Staff Report  
City of Richmond, Virginia

Commission of Architectural Review

7. COA-135960-2023.	<b>Final Review Meeting Date: 9/26/2023</b>
<b>Applicant/Petitioner</b>	William Shields
<b>Project Description</b>	<b>Result of a Notice of Violation:</b> Alter a front yard, concrete curb, veneering it in thin brick.
<b>Project Location</b>	
<b>Address:</b> 211 N. 27 <sup>th</sup> Street	
<b>Historic District:</b> St. Johns Church	
<p><b>High-Level Details:</b></p> <p>The Applicant proposes to alter a front yard, concrete curb by veneering it with brick.</p> <p>The concrete curb is located in front of a semi-attached Italianate, brick row house ca. 1894.</p> <p>The concrete curb spans the width of the two dwelling's front yards at 209-211 N. 27<sup>th</sup> Street.</p> <p>This work has been completed without receiving a Certificate of Appropriateness from the Commission.</p>	
<b>Staff Recommendation</b>	<b>Denial</b>
<b>Previous Reviews</b>	<p>While the Commission has not previously reviewed this application, Staff spoke with one of the dwelling's occupants about the proposal at the beginning of July 2023.</p> <p>Staff observed the work being completed without a COA on July 27, 2023

Figure 3. Completed work.

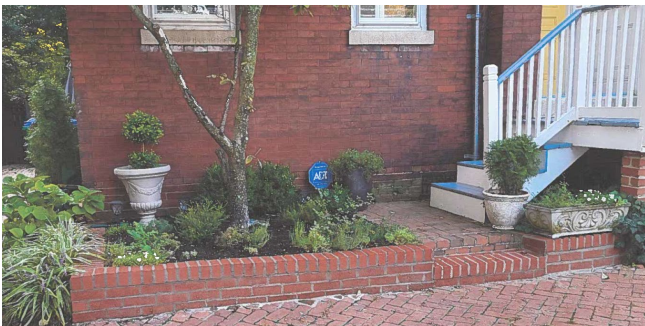
<b>Staff Contact</b>	Alex Dandridge, <a href="mailto:alex.dandridge@rva.gov">alex.dandridge@rva.gov</a> , (804) 646-6569
<b>Staff Recommendations</b>	<ul style="list-style-type: none"> <li>• denial of the application</li> <li>• original concrete curb be repaired and retained or reconstructed to match the original in height and dimension.</li> </ul>

<p>Standards for Site Improvements, Fences &amp; Walls, pg. 78</p>	<p><i>1. Original fences and walls should be retained and maintained whenever possible.</i></p> <p><i>2. Existing brick or stone walls, boxwood hedges, wooden picket fences and cast or wrought iron fences should not be removed or replaced with contemporary features.</i></p>	<p>The original concrete wall was not removed and exists beneath the brick veneer.</p> <p>It appears that the concrete retaining wall was cracked and in need of repair.</p> <p>Per the <i>Guidelines</i>, the concrete curb should have been repaired or reconstructed to match the original rather than covering the damaged curb with brick. <u>Staff recommends denial of the application, and recommends that the original concrete curb be repaired and retained, or reconstructed to match the original in height and dimension.</u></p>
